MMO
APPLICATION NO.	FILING DATE	FIRST NAMED INVENTOR	ATTORNEY DOCKET NO.	CONFIRMATION NO.
10/686,298	10/15/2003	G. Gary Gochanour	GGG-10402/29	7109
25006 7590 04/03/2007 GIFFORD, KRASS, SPRINKLE,ANDERSON & CITKOWSKI, P.C PO BOX 7021 TROY, MI 48007-7021			EXAMINER	
			LEE, LAURA MICHELLE	
			ART UNIT	PAPER NUMBER
			3724	
SHORTENED STATUTO	RY PERIOD OF RESPONSE	MAIL DATE	DELIVERY MODE	
3 MC	ONTHS	04/03/2007	PAPER

DETAILED ACTION

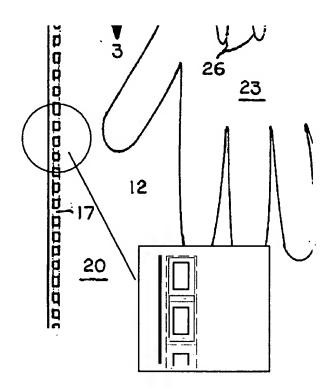
2. Applicant's arguments filed 1/08/2007 have been fully considered but they are not persuasive. The applicant contends that the Stephenson reference does not disclose the limitations of "a set of interlocking chains or opposing belts," and that rather the reference 17 merely constitutes perforations in a backing sheet. However, as defined by the Merriam-Webster Online Dictionary, a chain is a "series of things linked, connected, or associated together" and the term interlocked is defined as "to lock together or, to connect so that the motion or operation of any part is constrained by another. Therefore the limitation of an interlocking chain is can be interpreted as -- a series of locked things that are either linked, connected or associated together so that the motion or operation of any part is constrained by another. It is noted that as the material that surrounds the perforations is integral in the structural makeup of the perforation, and is shared by the proceeding and subsequent perforation, consequently, the perforations are integrally locked together. Therefore, the perforations form a chain by the material above and below, such that if the material weren't there, there wouldn't be a perforation, but a longitudinal slot in the film. Additionally, when any perforation is acted on by the toothed sprocket wheel, 16, movement is imparted to the film and conversely, the additional perforations, such that the motion of any part is constrained by another. The perforated chains are further depicted in the Figure below. As well, it

is also noted that parallel tear lines, 19, distinguishes one backing sheet from next, such that the tear lines define a boundary separating each group of perforations, thereby each backing sheet is comprised of one set of chains. Furthermore, the applicant contends that the chains or belts are required to be separate from the film. However, there are no limitations in claim 1 that establish that the set of chains or belts could not be attached to the film.
